**1 2 3 - ALTERATION NUMBER FOR SUBJECT APPLICATION**

Mark	Date	By	Chk.	App.	Revision
PL6	25/08/2021	ED	-	-	ISSUED FOR PLANNING ALTERATIONS

Job Title <b>PROPOSED DEVELOPMENT AT KINGSWOOD BUSINESS PARK, BALDONNEL, DUBLIN 22</b>	Drawing Title <b>SECTION A-A, B-B, C-C &amp; D-D</b>	Drawn ED	<b>KAVANAGH BURKE</b> CONSULTING ENGINEERS Tel: 01-450 0694 Unit G3, Calmount Pk. Fax: 01-426 4340 Ballymount, Email: pkavanagh@kavanaghuburke.ie Dublin 12.
Architect/Client <b>JMC VAN TRANS LTD</b>	Drawing Status <b>PLANNING ALTERATIONS 2021</b>	Checked LB	
		Approved LB	
		Scales AS SHOWN	
		Date August 2021	
		Job No <b>D1568</b>	Drawing No. <b>GA-A103</b>
			Rev. <b>PL6</b>

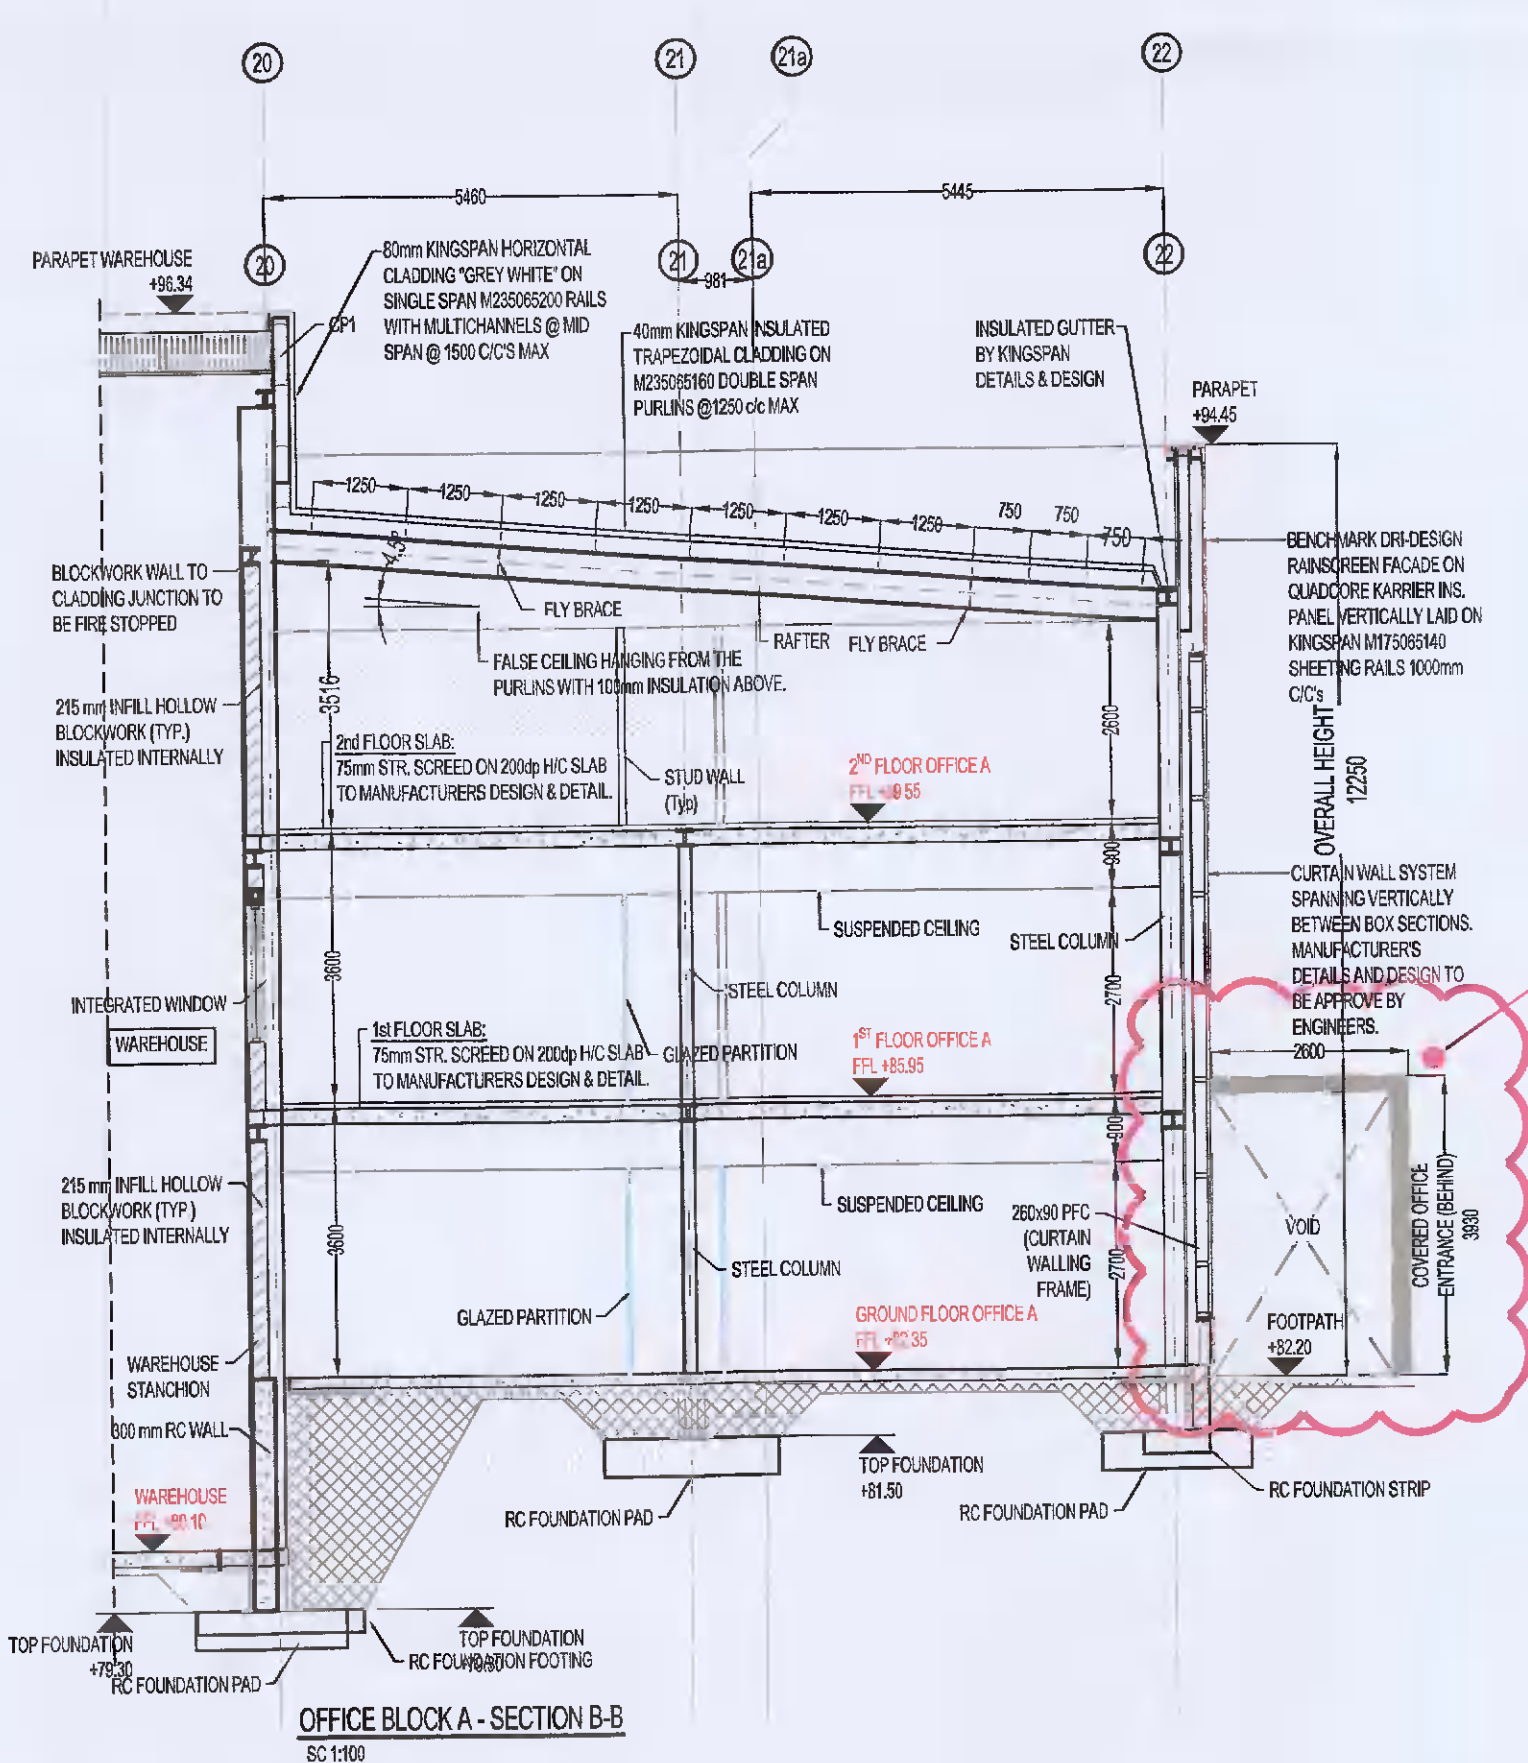
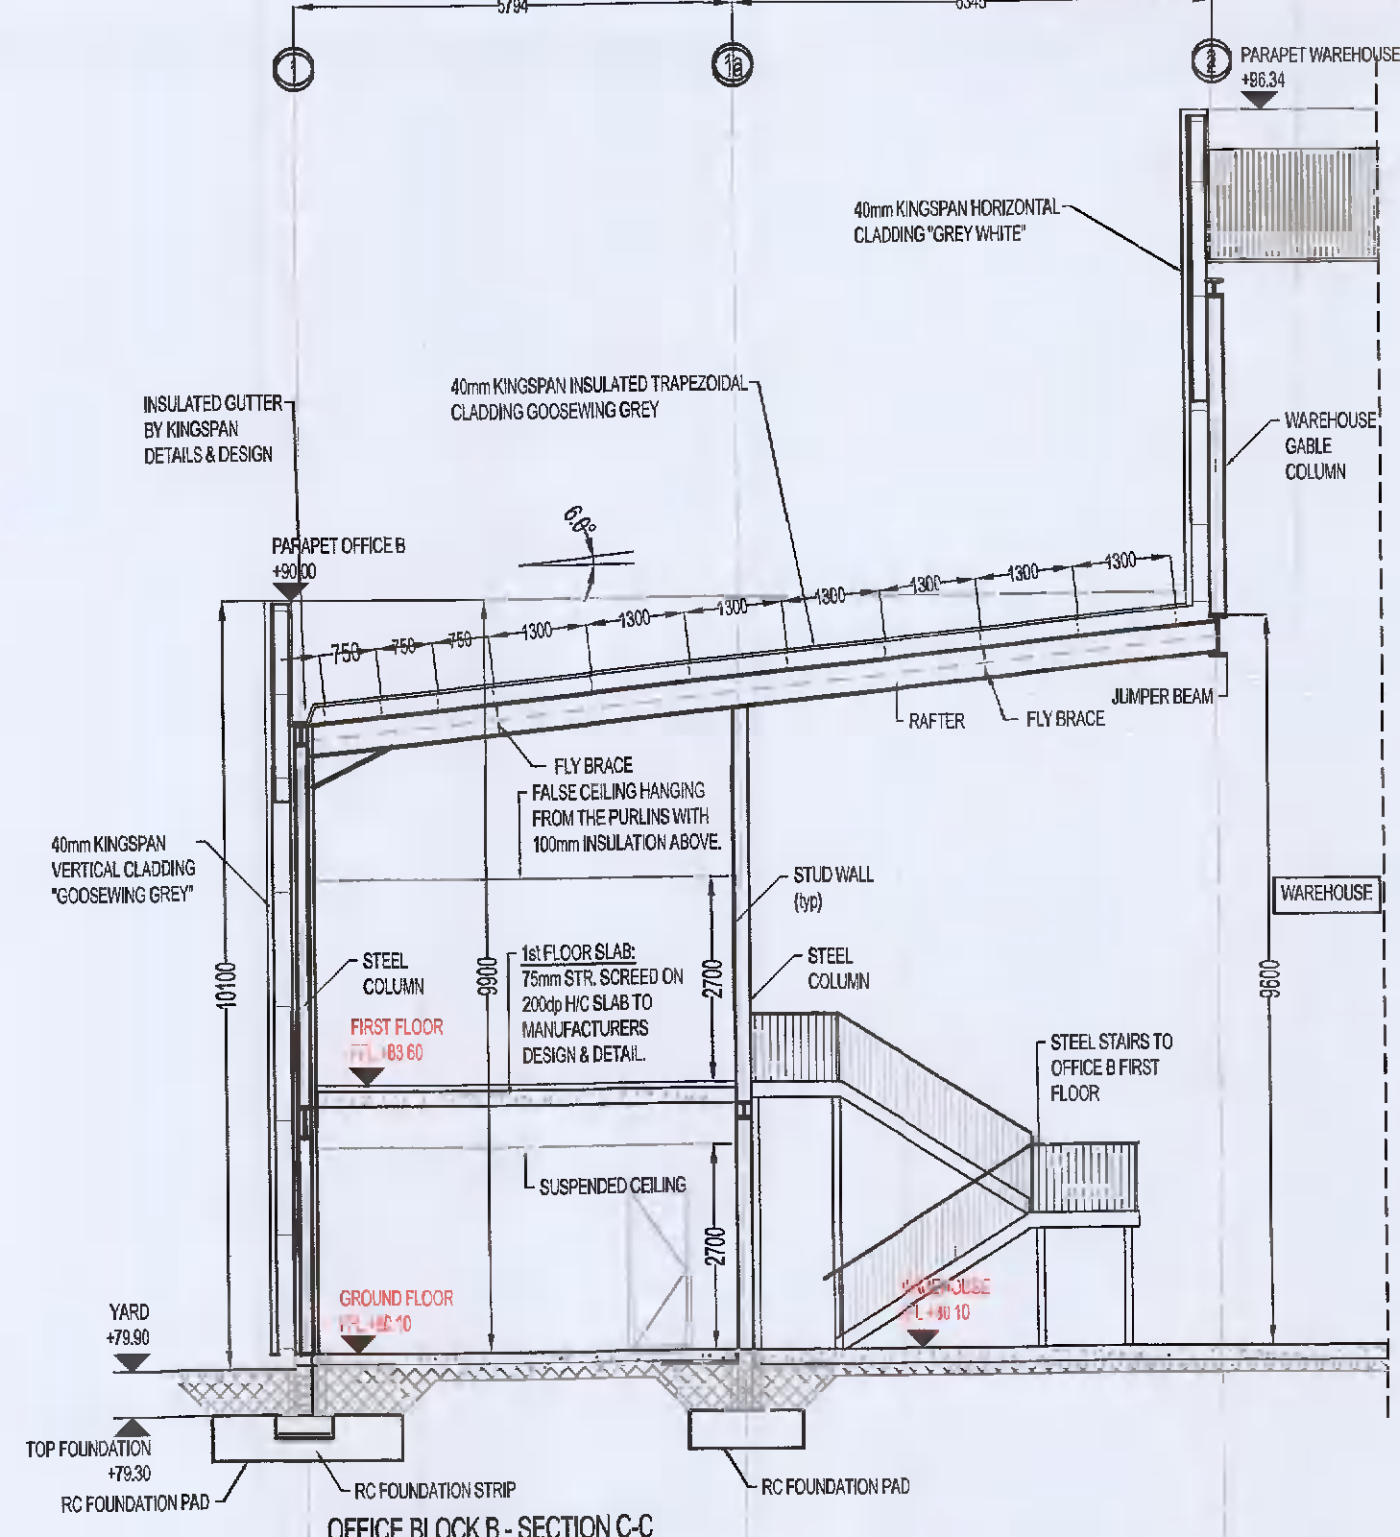
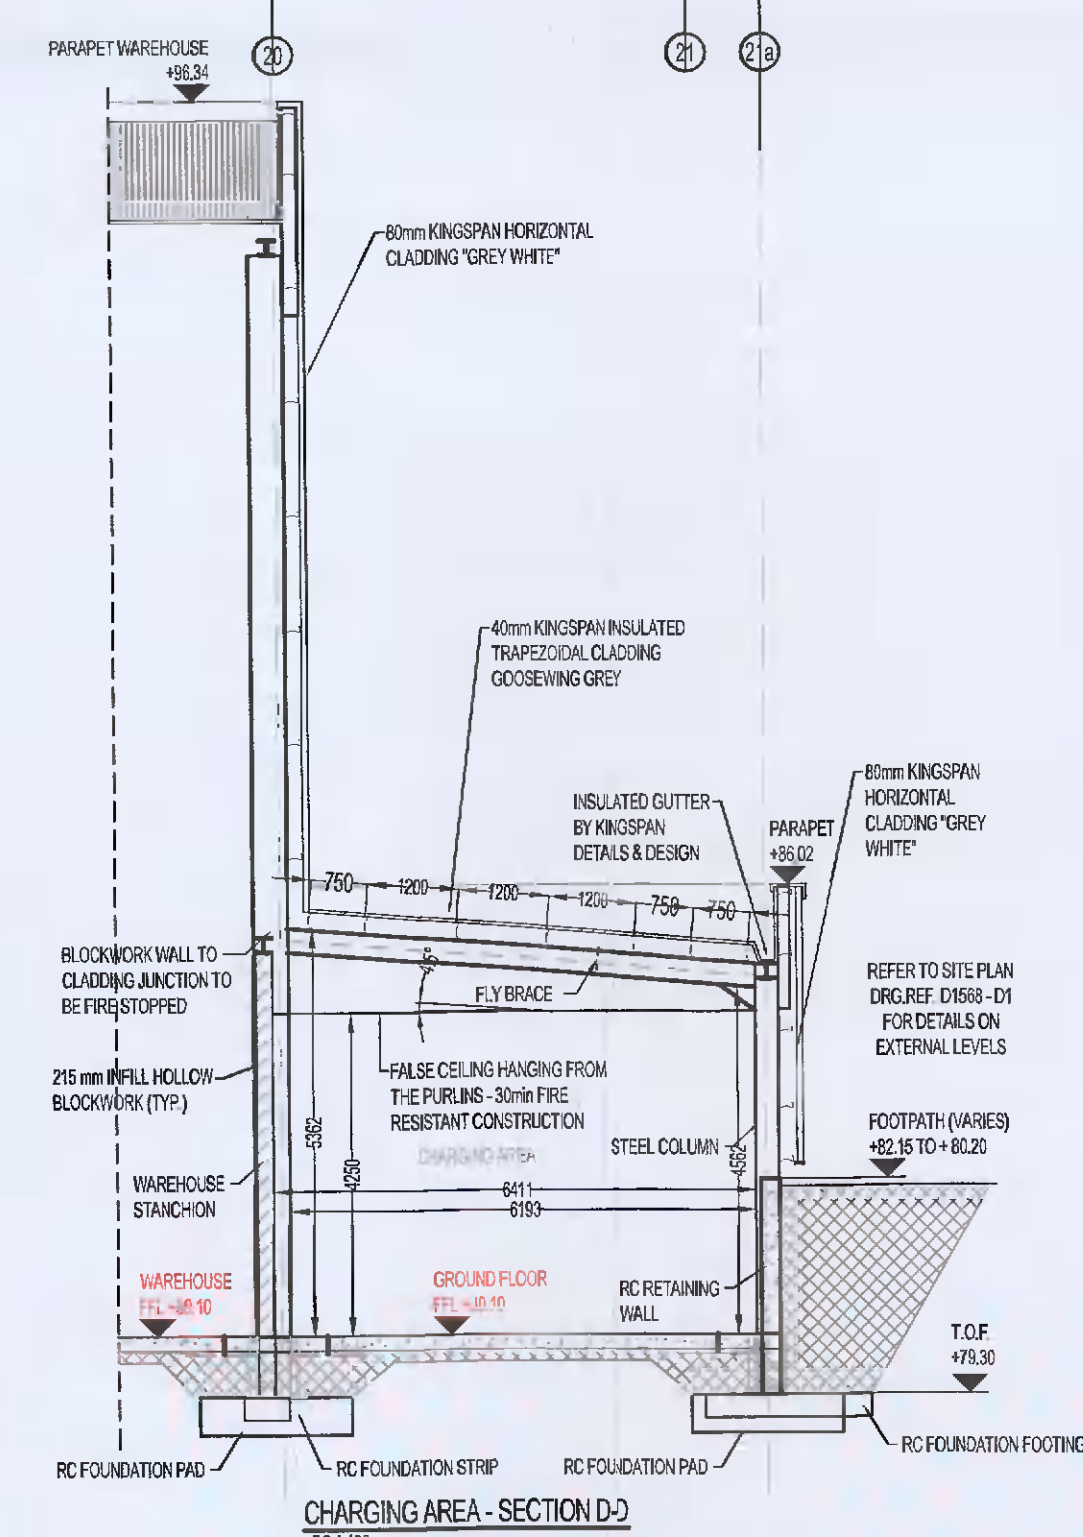
1. Reconfiguration of the ground floor area as follows:
  - A. Provision of a new ancillary storage area to the proposed building's eastern elevation measuring 75m<sup>2</sup>, at mezzanine level.

- B. Change of Use of 57m<sup>2</sup> of warehouse floor area to staff facilities due to the following:
    - B.1. Addition of single storey fire protected corridor from Office A to in the south-west corner of the warehouse, overall 45m<sup>2</sup> floor area addition.

- B.2. Addition of stairs from warehouse to mezzanine level, overall 12m<sup>2</sup> floor area addition.
2. Elevation alterations:
  - A. Introduction of covered glazed structure at the main Office entrance to the front (southern) elevation, overall height 6.10m;

- B. Introduction of integrated Modular Louvre System to Charging Area to the front (southern) and side (western) elevation;
  - C. Change of colour of southern elevation warehouse canopy to Anthracite; and

- D. Introduction of fire escape doors to the side (eastern) elevation.
3. Site plan alterations:
  - A. Omission of an existing roundabout and provision of revised road junction with an access/egress to the proposed development and to the existing Business Park;
